## SOUTH WEBER PLANNING COMMISSION AGENDA

Project Name: Riverwood Subdivision

- CC: Trevor Cahoon South Weber Community Services Director Kim Guill – South Weber Development Coordinator
- RE: RIVERWOOD SUBDIVISION (LARRY RAY / LYNN WOOD PROPERTY) Engineering Review (Preliminary)

#### RIVERWOOD SUBDIVISION (LARRY RAY / LYNN WOOD PROPERTY) Engineering Review (Preliminary) October 13, 2021

PRELIMINARY UTILITY PLAN

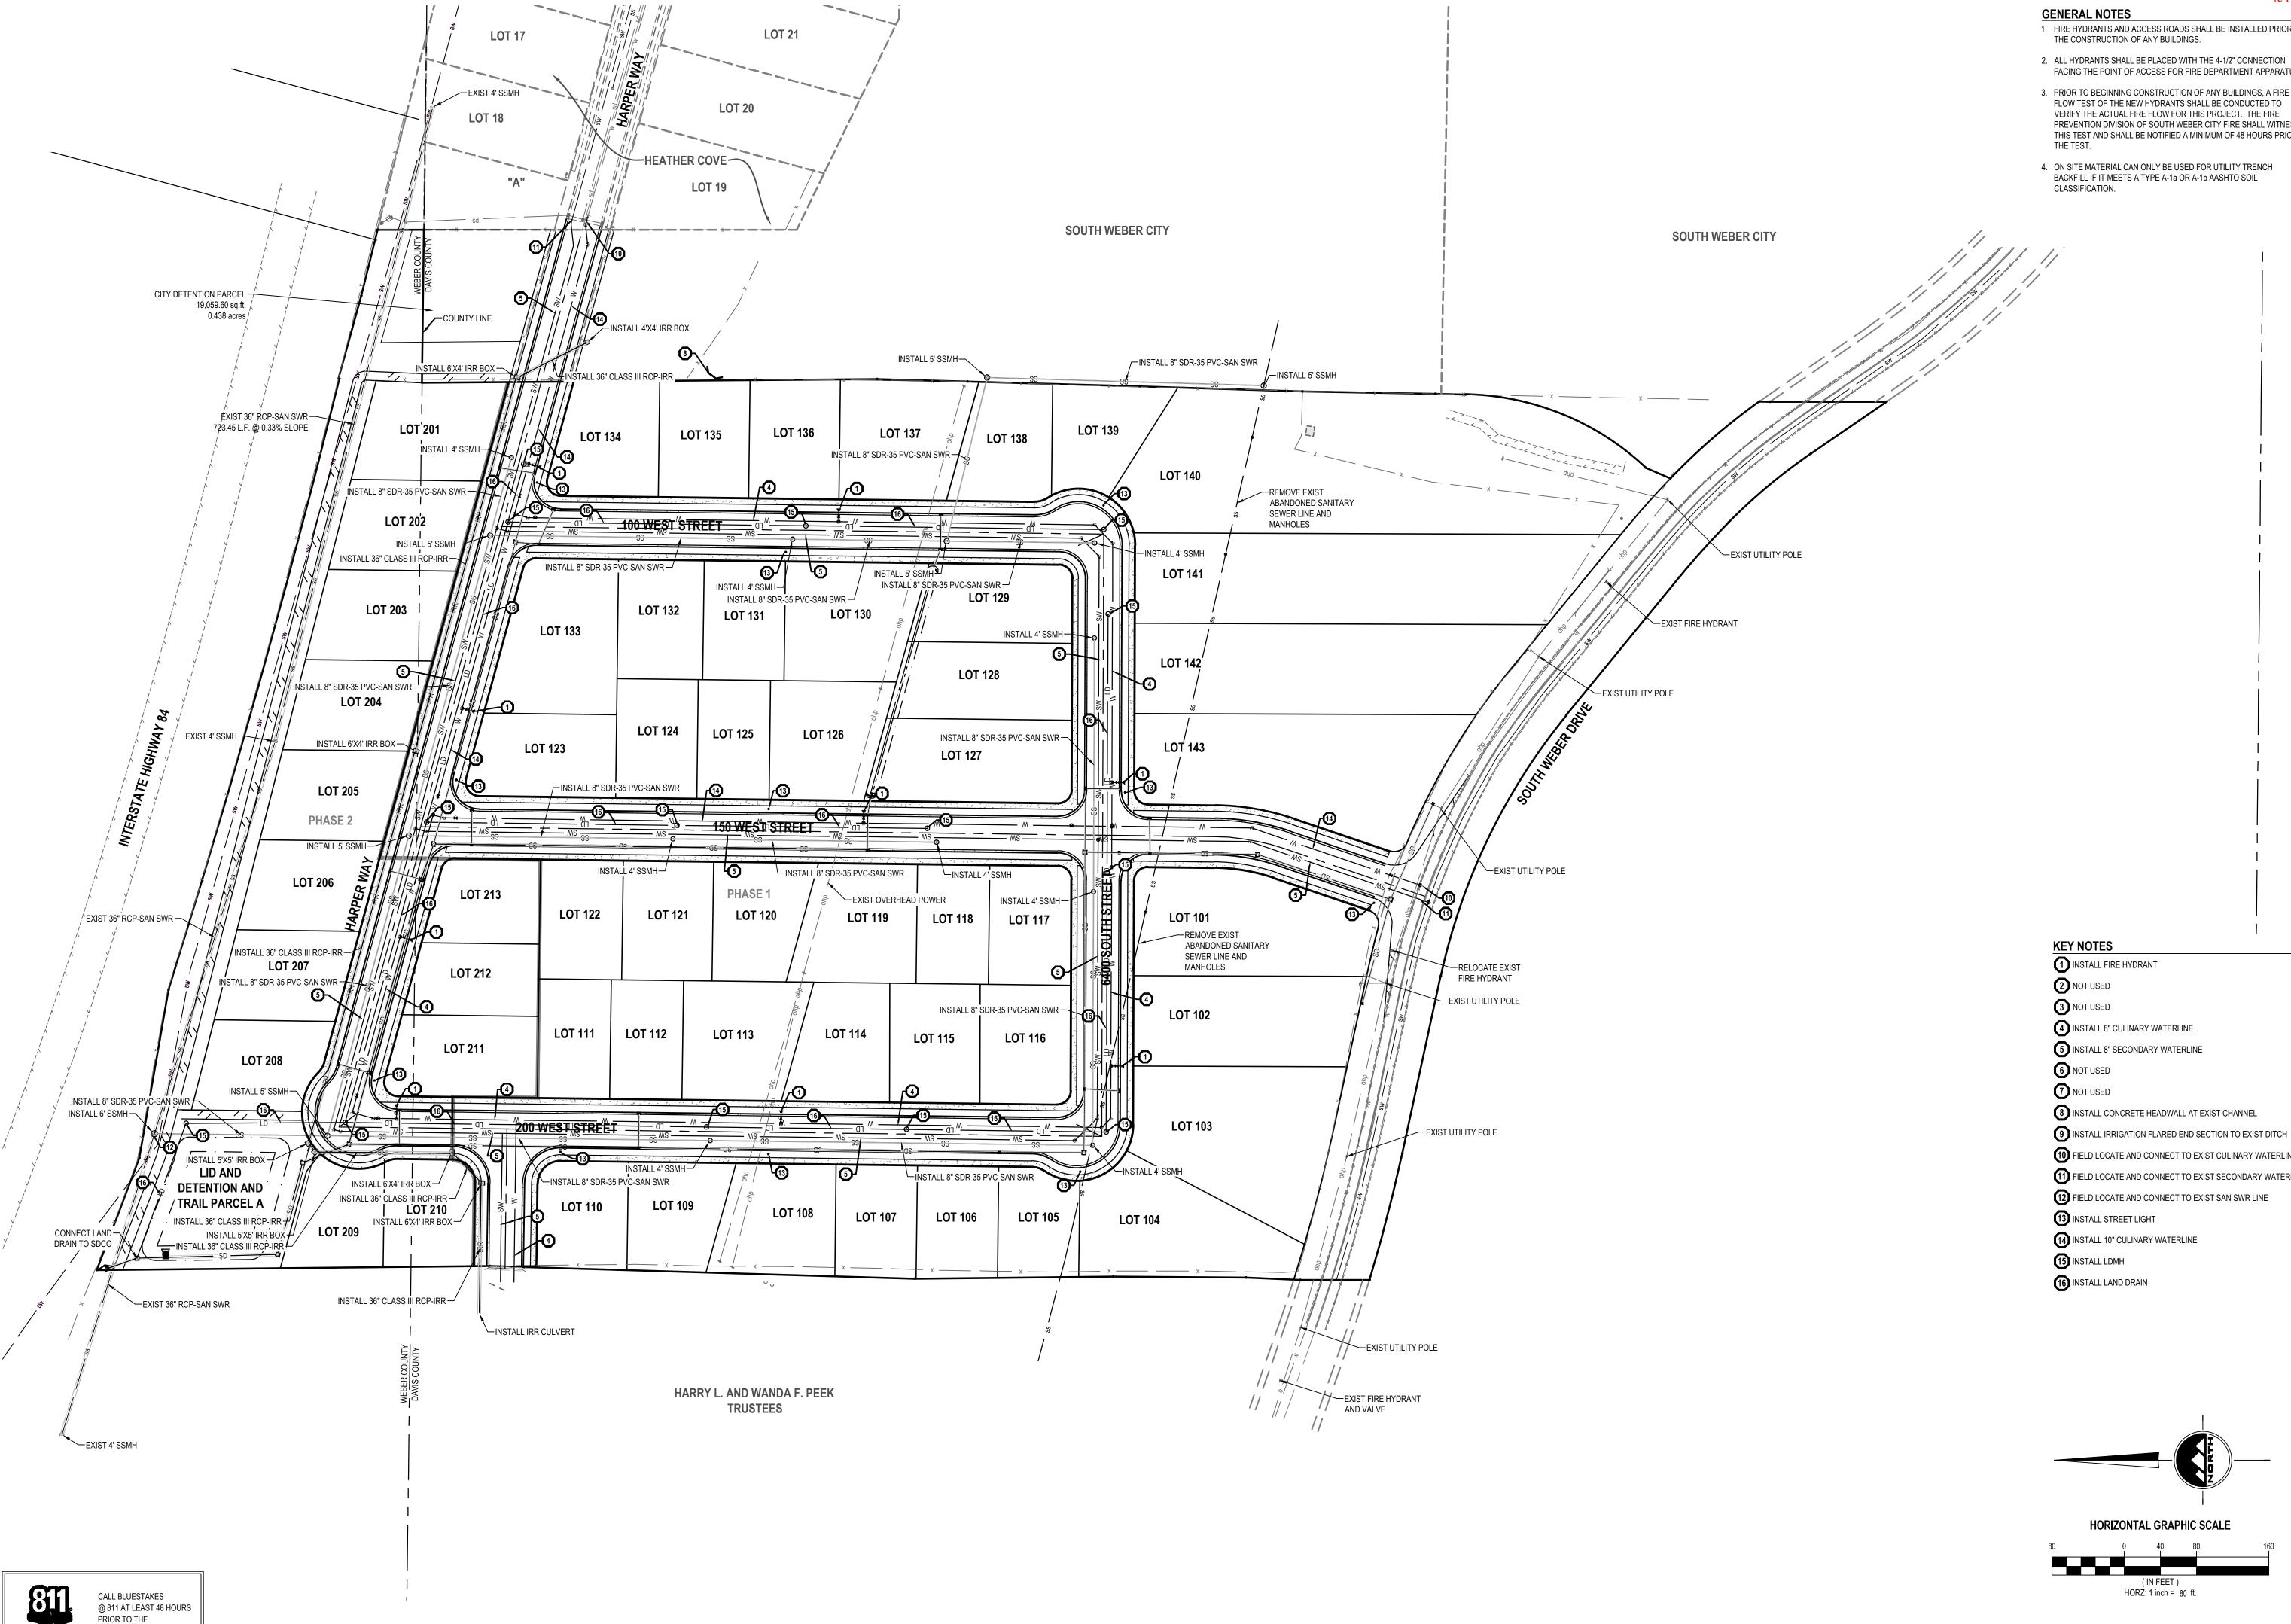
- E5. <u>Geotechnical Report.</u> The following comments are based on the study provided by CMT Engineering, dated June 15, 2021.
  - A. With a land drain system being added after the report was submitted, the geotechnical report needs to be updated (or addendum provided) addressing depths of the basement relative to each lateral to the lot. A reference table will need to be added to the plat giving the maximum depth of the lowest floor slab from the TBC elevation in front of the lot. Both the updated report and table on the plat will need to be part of the final submittal.

- B. No infiltration rate was provided. Most LID BMP's require infiltration. As part of the storm water LID analysis an infiltration rate will be required based on actual field testing or the minimum from the UCEA.net saturated hydraulic conductivity table for typical saturated infiltration rates may be used.

- C. The preliminary grading plan shows an average fill of about 2' across the entire site. If excess fill is required with the final design, the report should be updated (or an addendum provided) to address any issues related to the additional fill.

- D. On site material can only be used for utility trench backfill if it meets a Type A-1a or A-1b AASHTO soil classification.

- E9. Storm Drain.
  - A. Stormwater Low Impact Development (LID) best management practices are required for this development. The preliminary plans show retention in the detention basin. Prior to final, the Storm Water Quality Report will need to be provided, and any additional BMP's shown in the drawings.
    - i. Follow State's Guidelines at <u>https://deq.utah.gov/water-quality/low-impact-development</u>
    - ii. Follow State's "Guide to Low Impact Development within Utah Manual"
    - iii. Complete State's <u>"Storm Water Quality Report Template"</u>
- E10. <u>Trail.</u> In accordance with the General Plan, and consistent with other developments, a 10' wide asphalt trail (3" HMA, 4" UTBC) is being provided. It is located between I-84 and the backyards of the homes on Harper Way.
